Dockets Nos. 50-245
and 50-336

The Commission has issued the enclosed Amendments Nos. ⁴⁴ and ³⁵ to Facility Operating Licenses Nos. DPR-21 and DPR-65 for the Millstone Nuclear Power Station, Units Nos. 1 and 2. The amendments consist of changes to the Technical Specifications and are in accordance with your application dated May 11, 1977 as revised by letters dated July 11 and December 15, 1977.

These amendments consist of changes in the Technical Specifications that incorporate the Fire Protection System into the Limiting Conditions for Operation, Surveillance Requirements and Administrative Controls.

Amendment No. 44
License No. DPR-21

Figure 6.2-2 Facility Organization – Millstone Nuclear Power Station - Unit 1

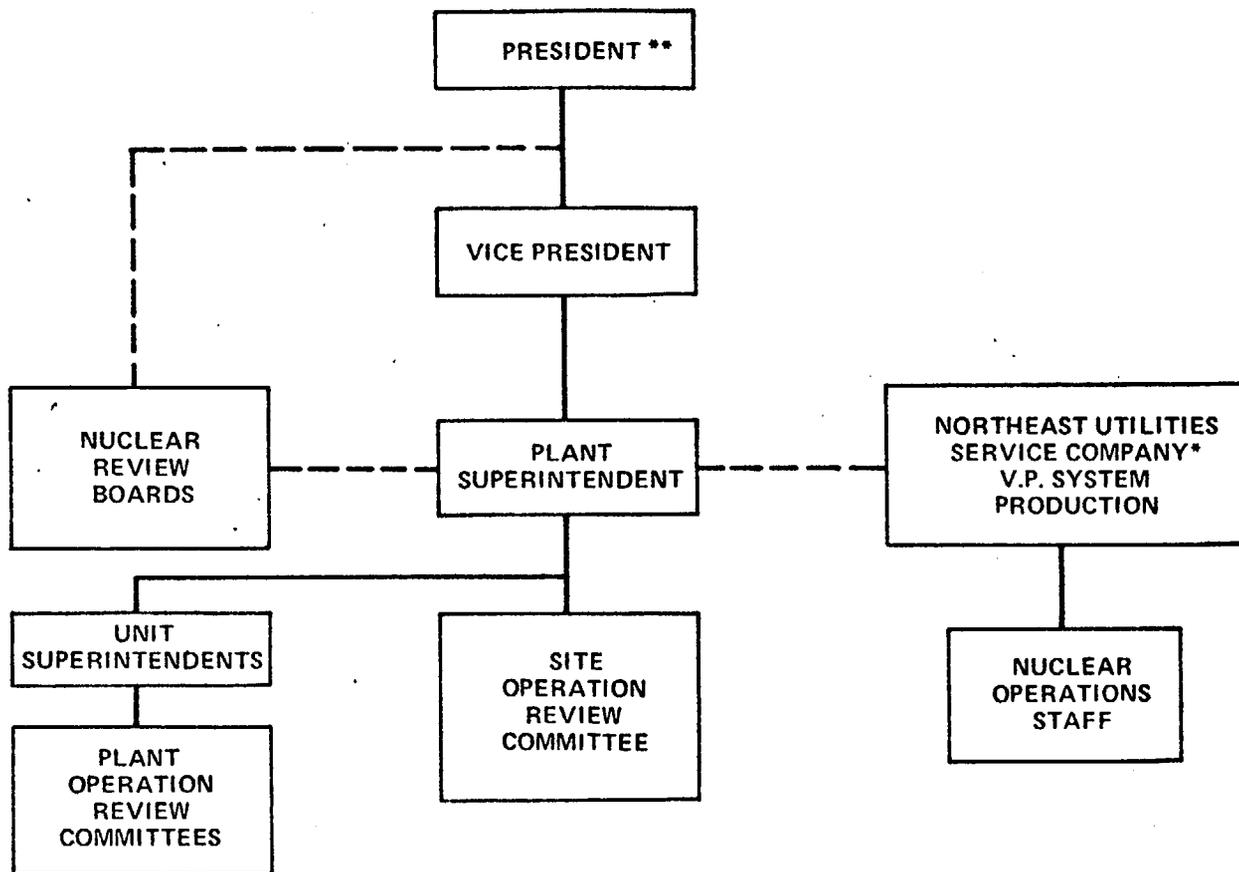
CODE: LO - LICENSED OPERATOR
 LSO - SENIOR LICENSED OPERATOR
 * OVERALL SITE RESPONSIBILITY FOR FIRE PROTECTION

Figure 6.2-1 OFFSITE ORGANIZATION FOR FACILITY MANAGEMENT AND TECHNICAL SUPPORT

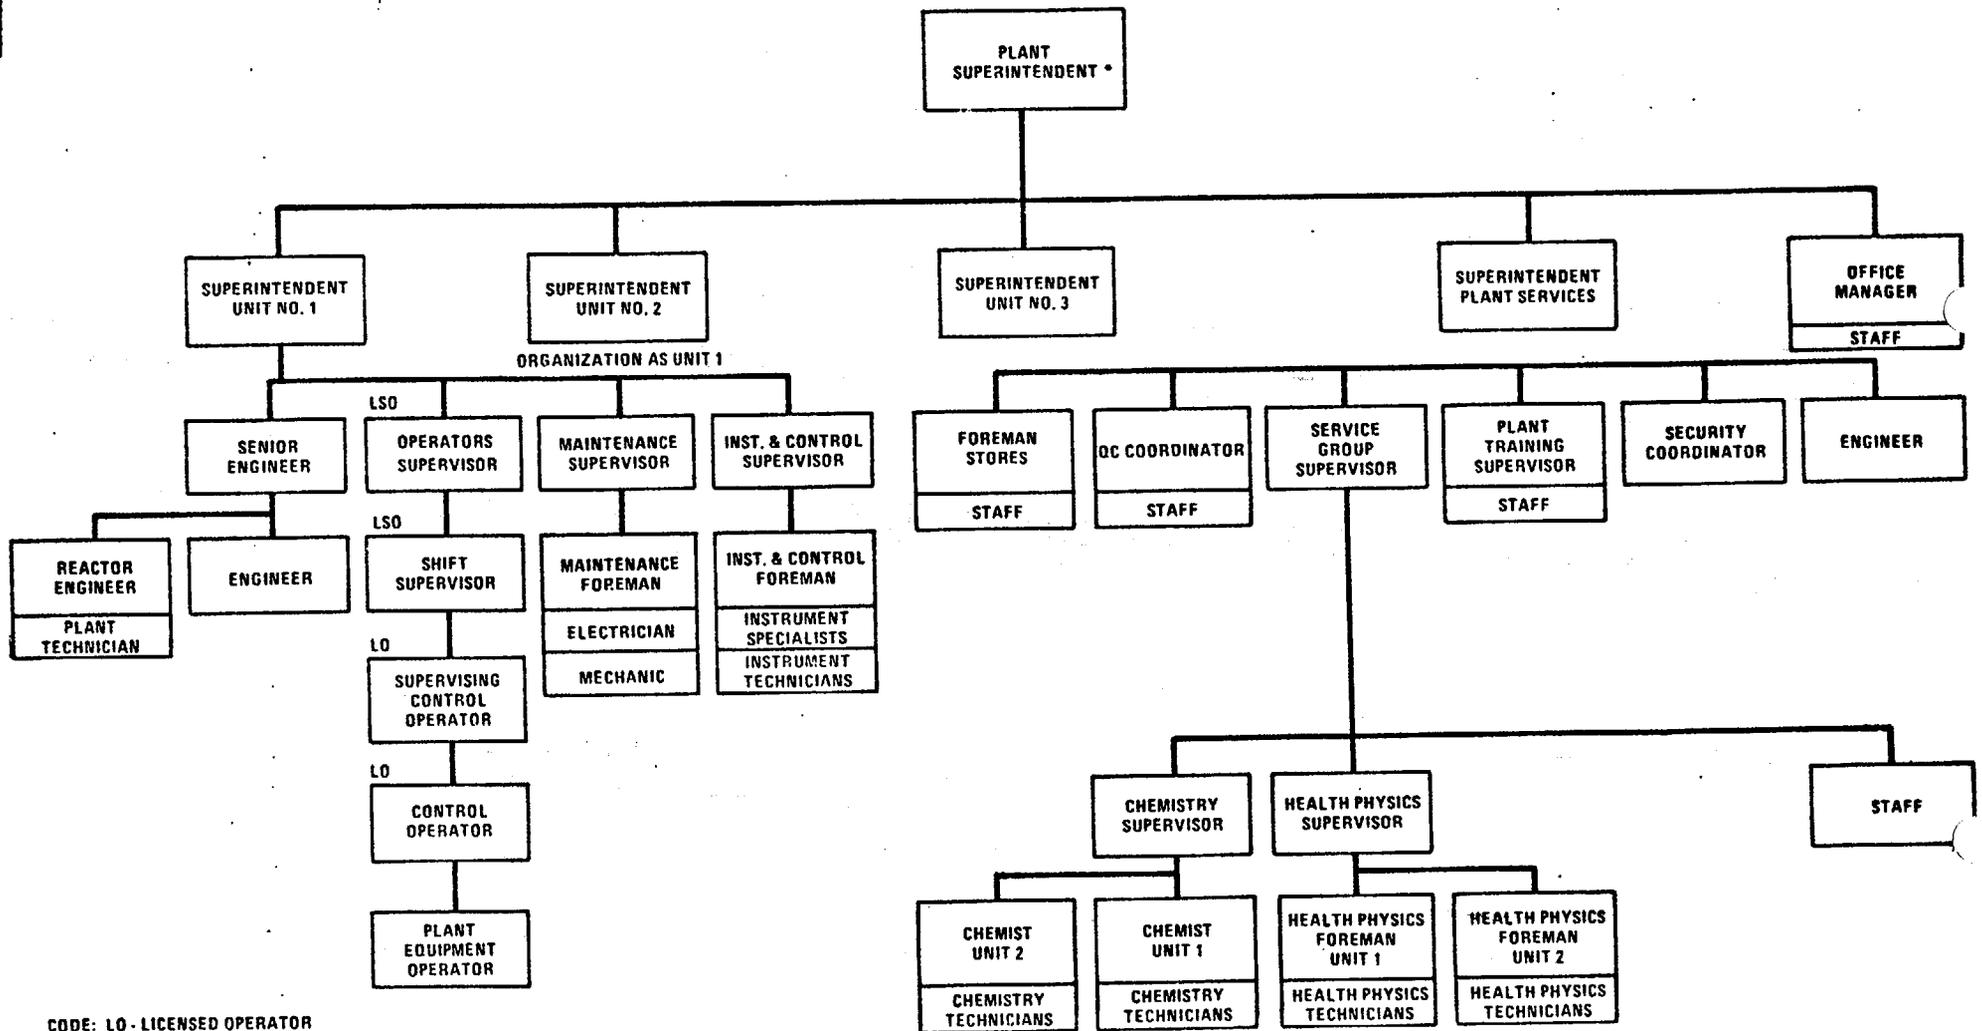
- * PROVIDES OPERATING AND ENGINEERING SUPPORT BY CONTRACTUAL ARRANGEMENT
- ** OVERALL CORPORATE RESPONSIBILITY FOR FIRE PROTECTION

Figure 6.2-2 Facility Organization – Millstone Nuclear Power Station - Unit 2

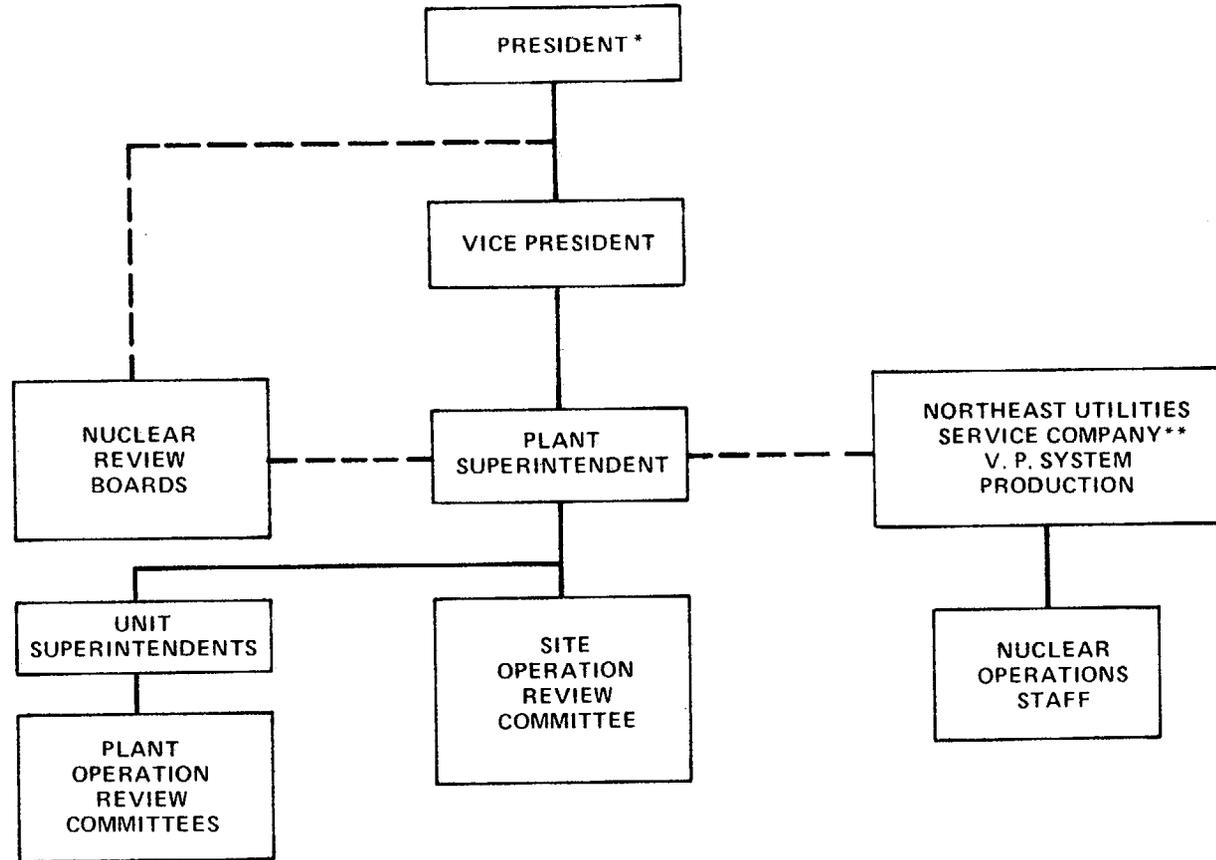
* OVERALL SITE RESPONSIBILITY FOR FIRE PROTECTION

Figure 6.2-1 Offsite Organization for Facility Management and Technical Support

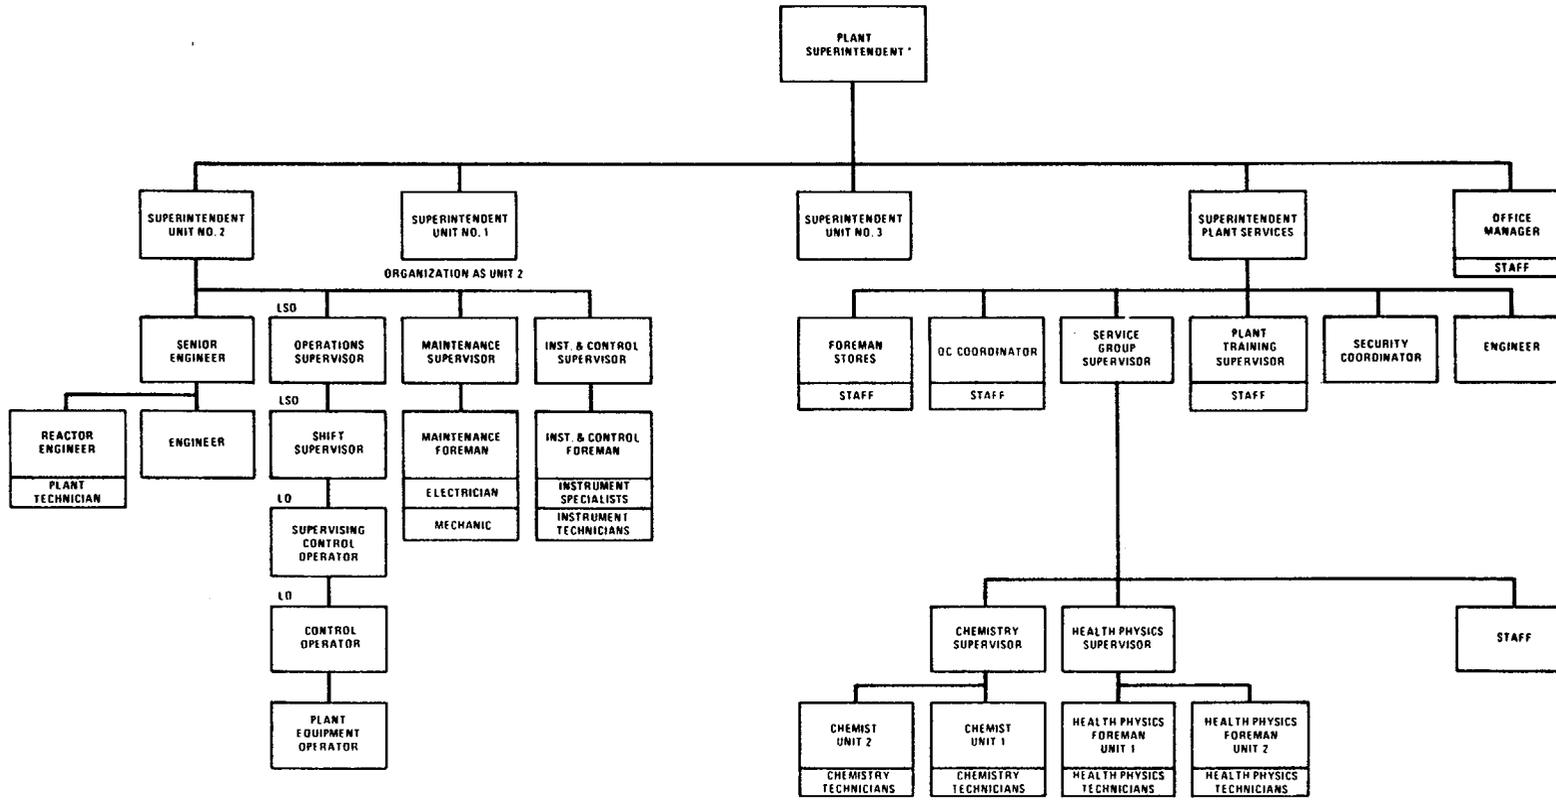
- * Overall Corporate Responsibility for Fire Protection
- ** Provides Operating and Engineering Support by Contractual Arrangement
